**VALUE ENGINEERING STUDY  
OF**

***US 41A  
HOPKINS COUNTY***

**PROJECT ITEM NUMBER: 02-0137.00**

***FINAL REPORT: AUGUST 31, 2011***

***Value Engineering Alternative No. 1: Use the existing alignment, leave the roadway connection as is and lengthen the right turn lane on US 41A and provide a traffic signal.***

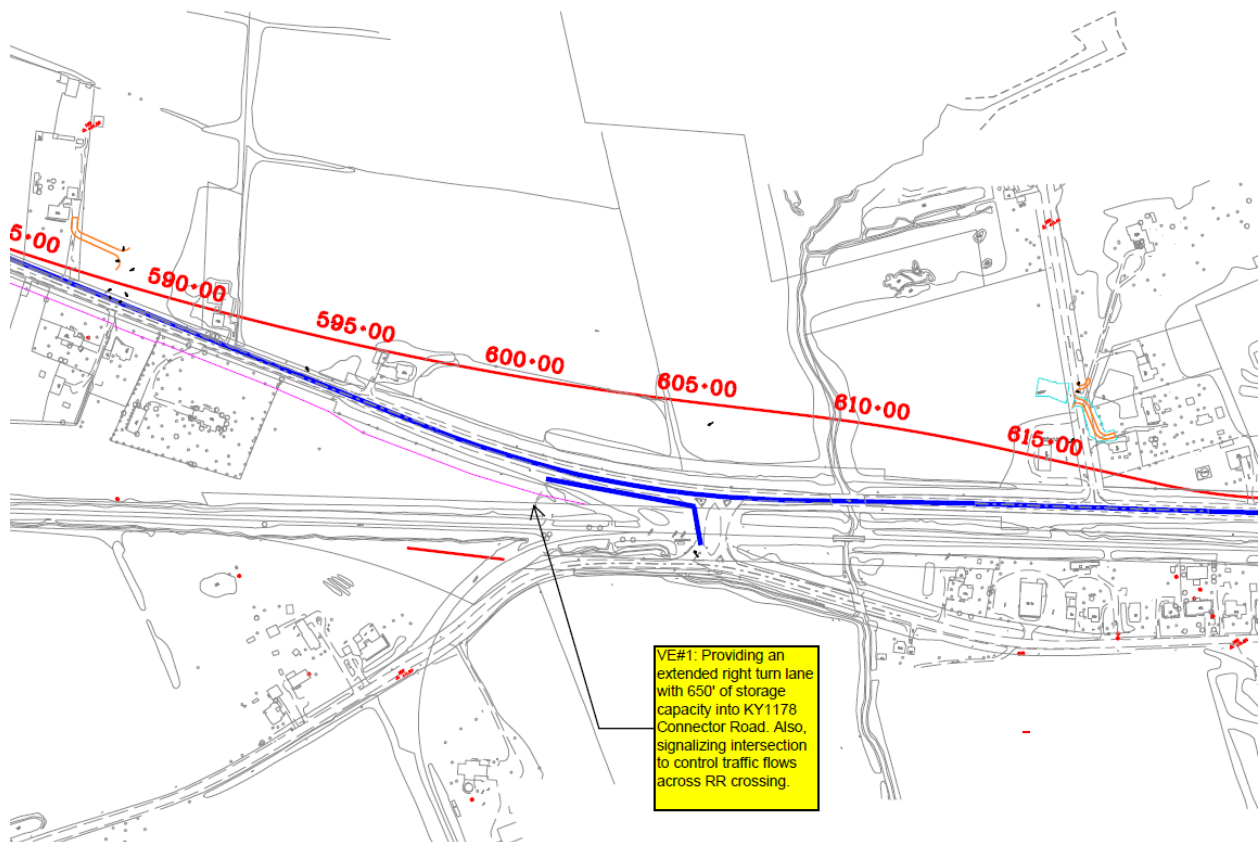
Value Engineering Alternative No. 1 consists basically of using the existing US 41A alignment by overlaying the existing pavement and widening on the north side of the roadway from station 575+00 to station 630+00.

#### *Value Engineering Alternative No. 4: Use a 4' raised median.*

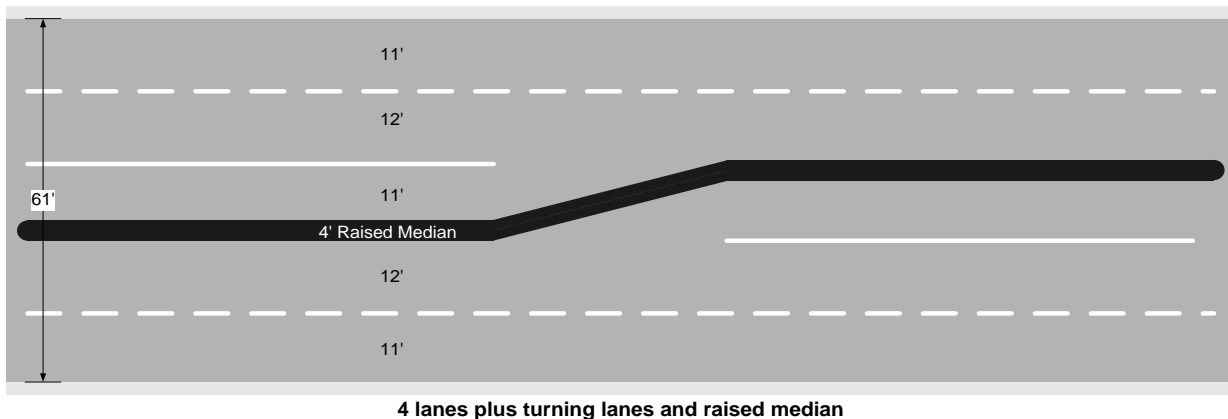
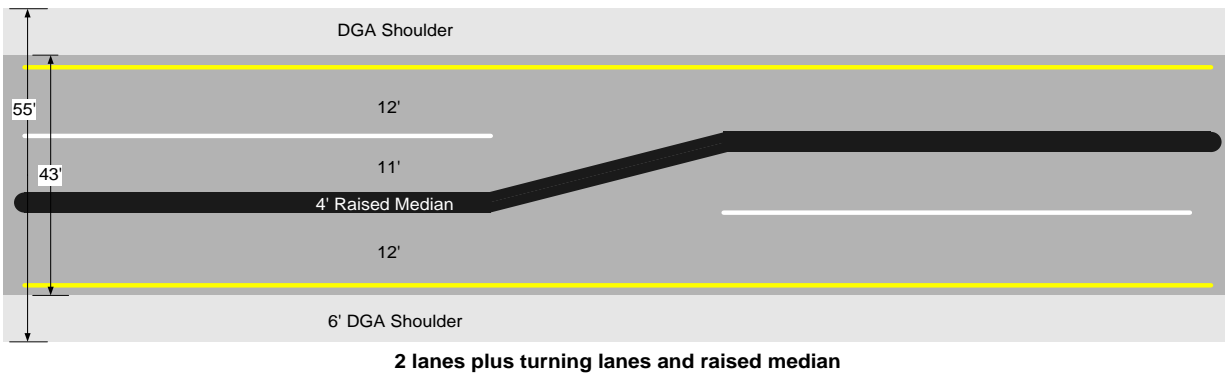
The Value Engineering Team recommends modifying the typical section throughout the project to add a raised median to form channelized turning lanes in lieu of the continuous two-way left turn lane (TWLTL.)

To achieve this, the road will need to be widened by six feet, which is an increase to the project cost. An integral concrete four feet six-inch raised concrete median. An additional one foot of pavement would be added to allow for a 12' travel lane. The project team will also need to accommodate for intermittent drainage outlets along the median in the superelevated section.

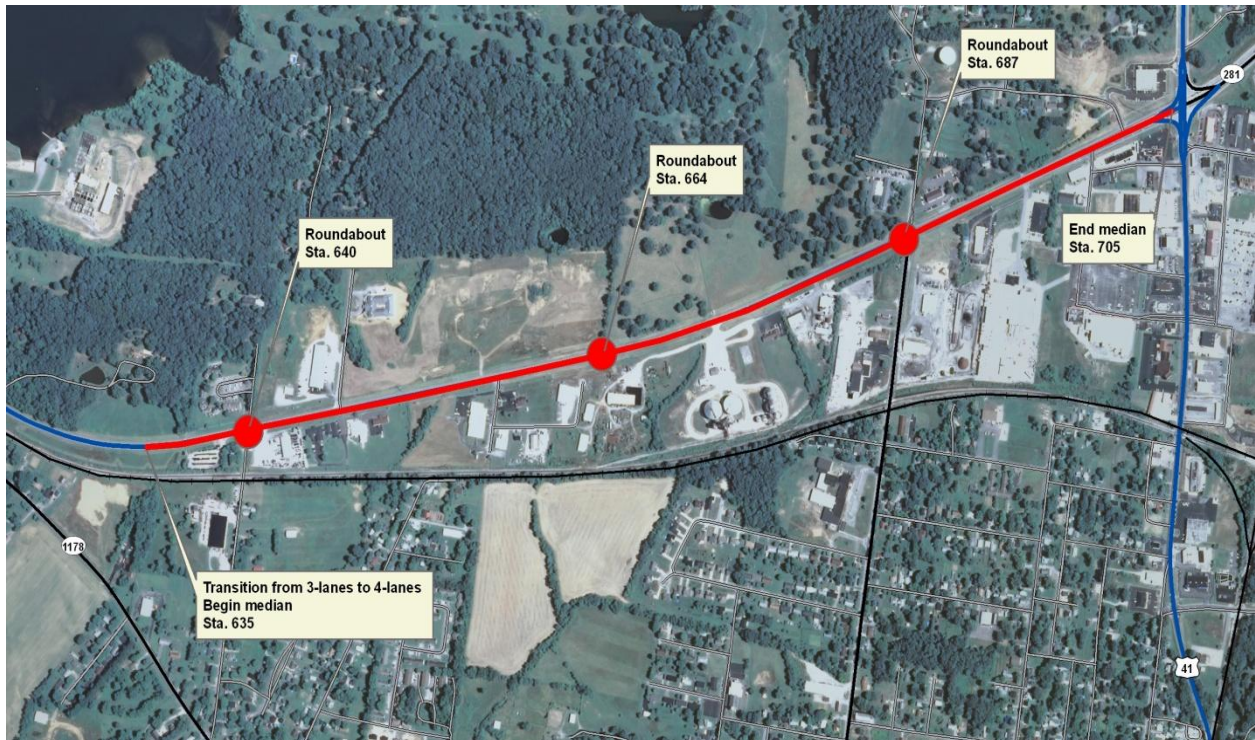
The Value Engineering Team recommends modifying the urban typical section throughout the project to add a six-foot raised median between stations 635+00 and 705+00. There are three roundabouts located on this section to allow for u-turns to facilitate access to properties along the corridor. The division point between two through lanes (rural section) and four through lanes (urban section) is shifted from station 605+00 to 635+00 (3,000').

The projected volumes on this section of road for 2032 are 22500 vehicles per day. Using the traffic forecasts assumed 2% growth rate factor, by 2036, the volumes on this road may exceed 24,000 per day. Design memo 03-09, recommends that a non-traversable median be used in lieu of a TWLTL when daily volumes exceed 24,000. This is to help better facilitate traffic flow and maintain a safer roadway environment by controlling turning movements.

Preliminary analysis indicates that roundabouts will work sufficiently at the given intersections. Pride Avenue was analyzed because it will the intersection with the heaviest traffic volumes. Forecasted PM design hour volumes using a 2031 forecast year were input into both the Kentucky Transportation Center (KTC), Roundabout Capacity Tool, KTC Intersection Tool and the FHWA Alternative Intersection Selection Tool (AIST) show that a major/minor roundabout design will work for this location. A major/minor roundabout typically has two lanes entering the roundabout along the mainline highway and one lane entering from the side street or entrance. During the future DHV, delays are be project at less than 9 seconds on average for all vehicles and there is no more than one car queued in all directions.

### VALUE ENGINEERING RECOMMENDED US 41A PROFILE

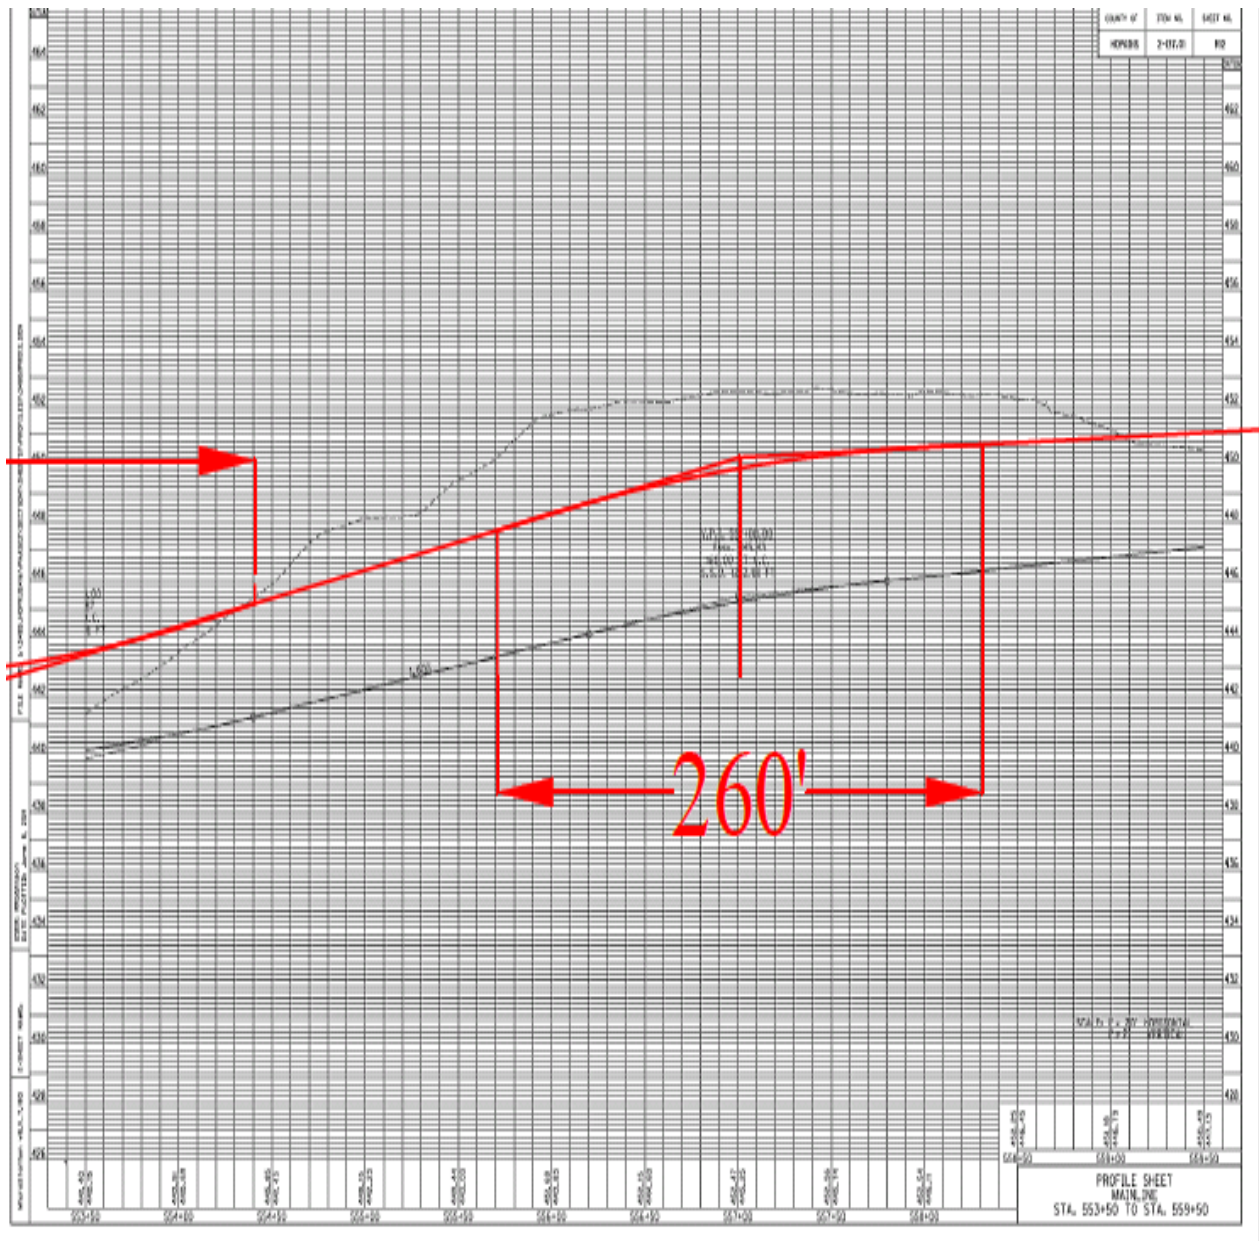
The Value Engineering Team recommends purchasing the railroad spur. The removal of the railroad spur will eliminate the railroad protection system and crossing material. Without the railroad spur the profile of US 41A could be modified to increase the sight distance, reduce the amount of excavation, and eliminate the purchasing of an industrial facility. The vertical alignment will reduce the excavation and bring the project closer to a balance project.

#### **VALUE ENGINEERING PARTIAL DISPLACED LEFT TURN INTERSECTION**

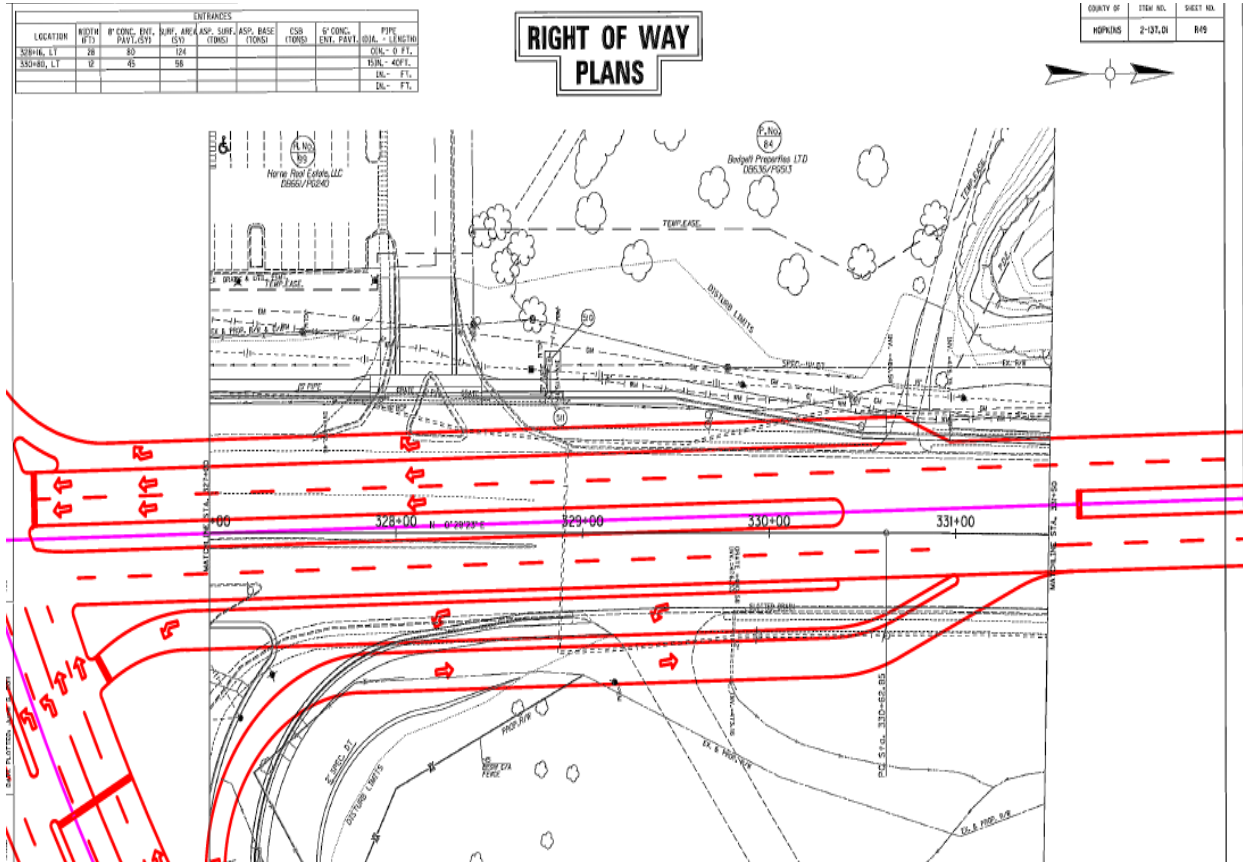
This Value Engineering Alternative will configure the interchange with a Partial Continuous Flow Intersection or also know as a Partial Displaced Left Turn Intersection as shown below.

It is a Partial Displaced Left Turn Intersection because only the north and south left turn movements are displaced. This unique configuration removes the north and south left turn movements from the signal timing by allowing the left turn movement to occur at the same time as the through movement has a green light. This eliminates one signal phase providing additional time to the other three phases.

This design will require more curb and gutter, have a slightly larger foot print, more pavement and a more complex signalization system. The signal system will require additional signals for the displaced lefts.

### VALUE ENGINEERING SOUTH APPROACH

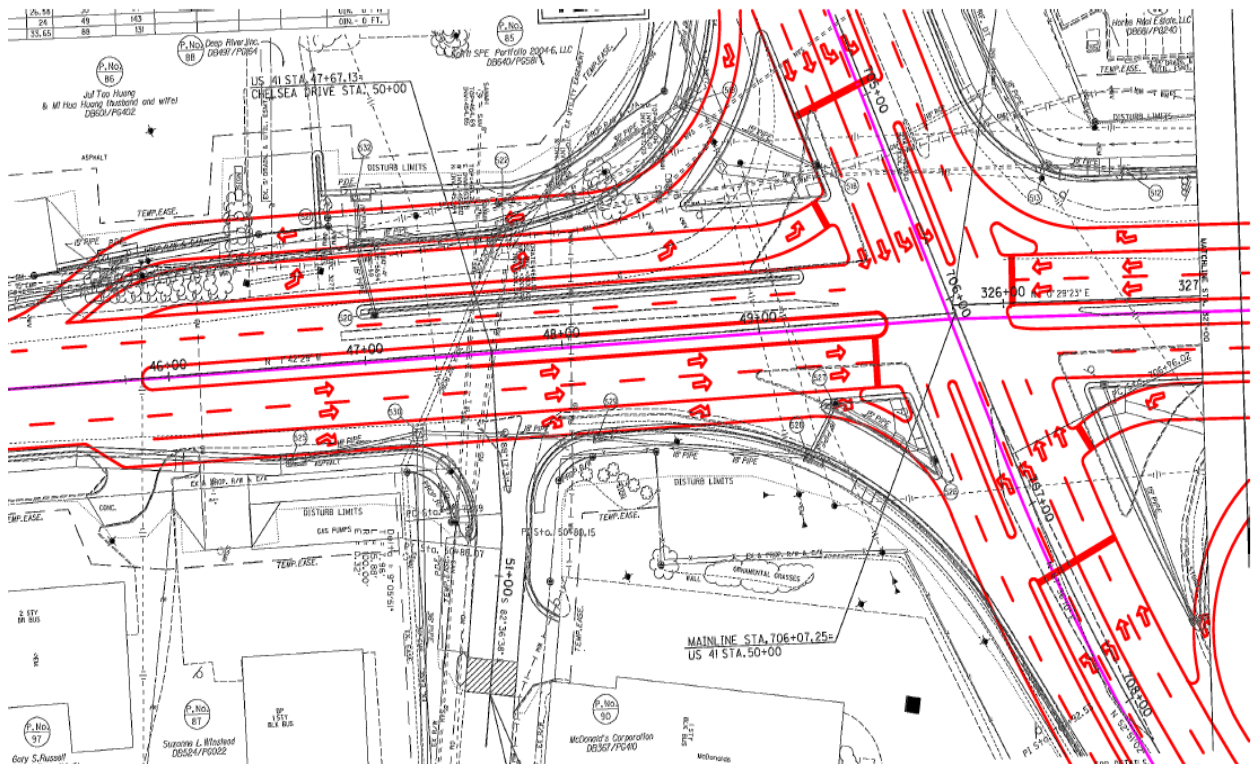
Traffic analysis was completed on the FHWA Alternative Intersection Selection Tool. The analysis indicated both the conventional as well as the Displaced Left Turn Intersection will operate satisfactorily in the design year, but the Displaced Left Turn Intersection will provide more capacity and should have a longer useful design life.

#### VALUE ENGINEERING ALTERNATIVE ROUNDABOUT

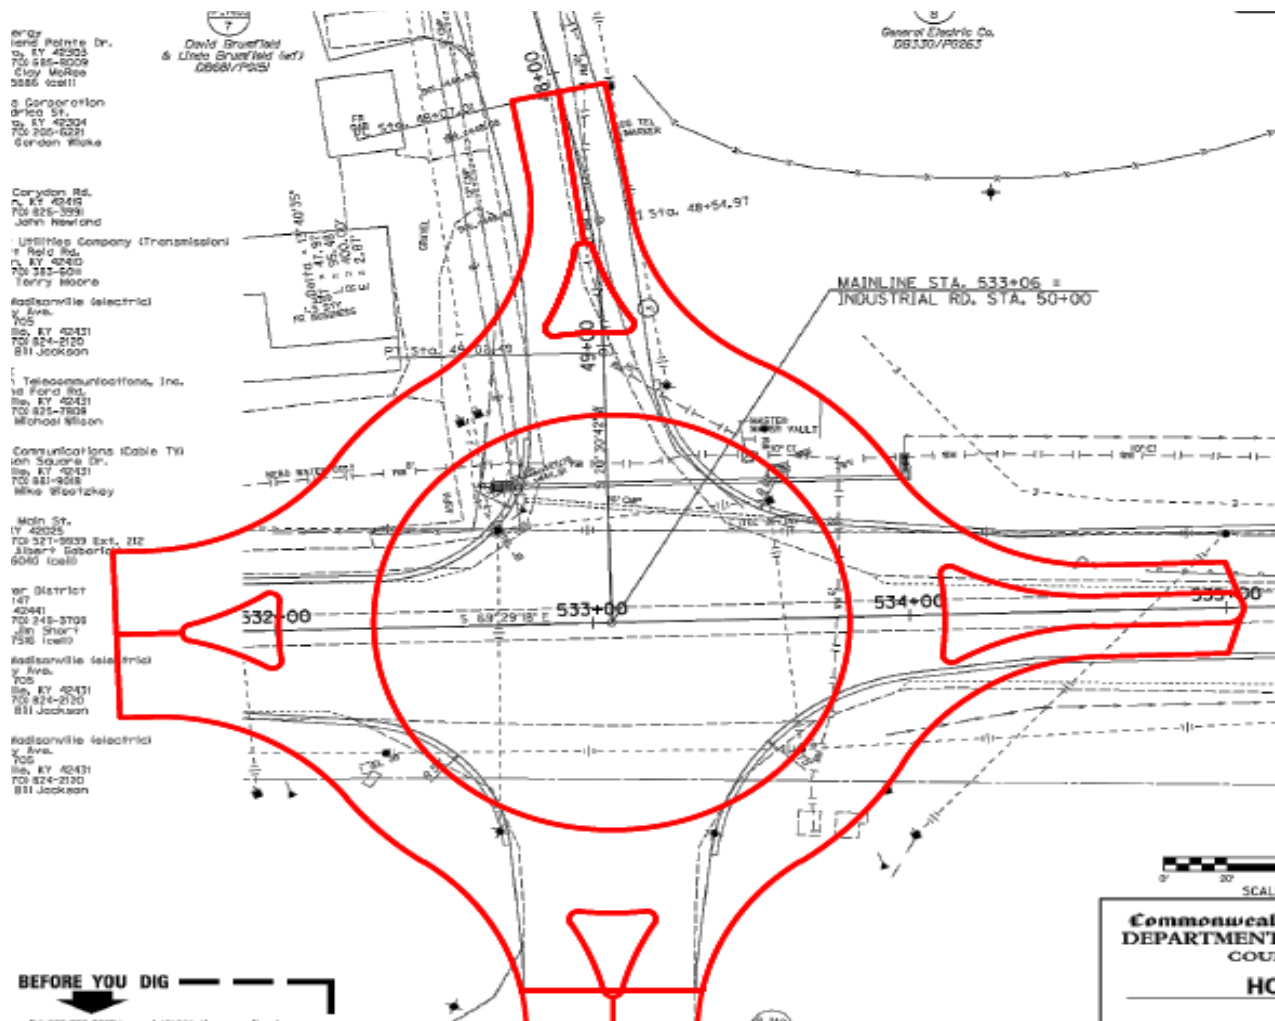
The Value Engineering Alternative is to construct a roundabout in this location as shown below.

The roundabout will alert the driver to the change in characteristics of the roadway. It will also reduce overall delay for the drivers because there is no signal to stop traffic. Additional adjustments to the alignment can be made to avoid any adverse Right-of-Way takes.

#### VALUE ENGINEERING ALTERNATIVE ROUNDABOUT WITH RAISED MEDIAN

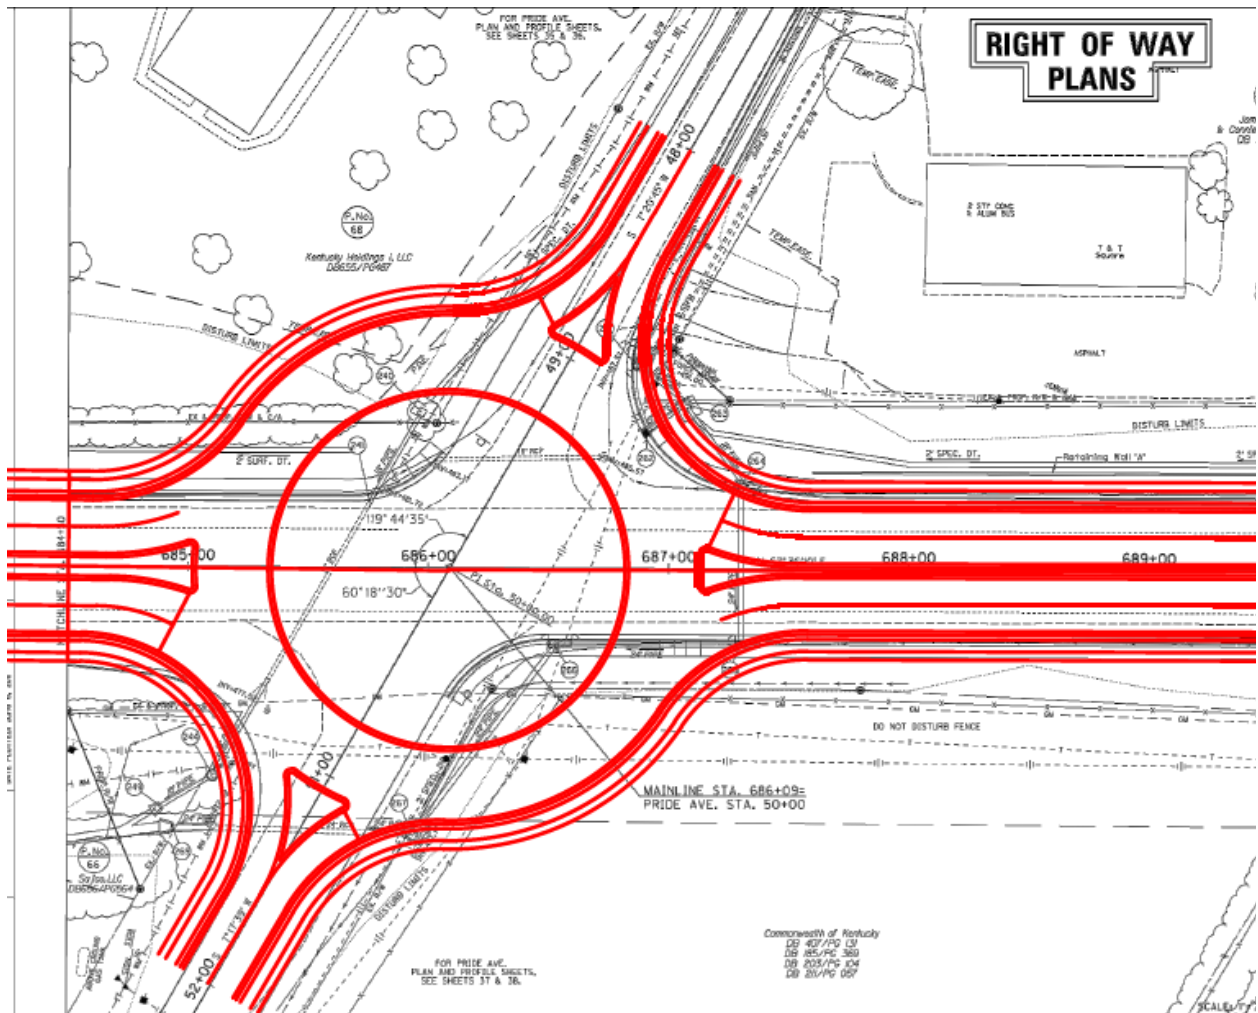
The Value Engineering Team recognizes that this section of roadway has Access Management issues. Between Pride Avenue and North Main Street/US 41 there are three commercial driveways and one residential driveway. During the AM and PM peaks traffic hours it will be difficult and risky to make left turns into these driveways. To reduce these risks, this Value Engineering Alternative will construct a 4' raised median from Pride Street to North Main Street/US 41 and a roundabout at Pride Avenue. This will require drivers wishing to make left turn to make U-Turns either at the roundabout or the signalized intersection at North Main Street/US 41.

The roundabout will require corner clips in 2 of the 4 corners. It is also understood this intersection is not designed to be signalized now, but it may soon warrant a signal.
